WELL TEST ANALYSIS

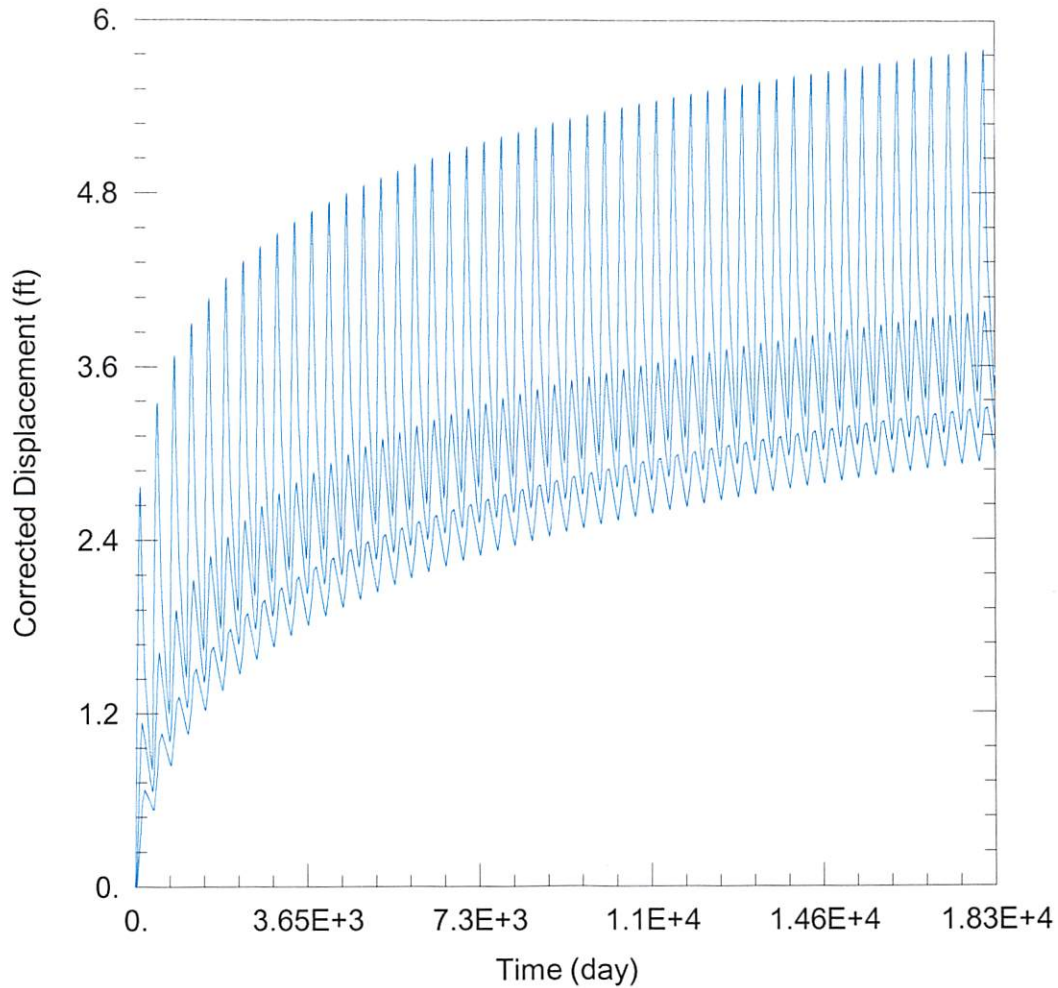
Net drawdown exceeds the drawdown allowance of 3.0 ft for the well authorized under water right nos. 5043 & 7509. Critical well analysis is necessary on that well.

Total drawdown of 70.4 ft is greater than the EDC, so this well is **critical**.
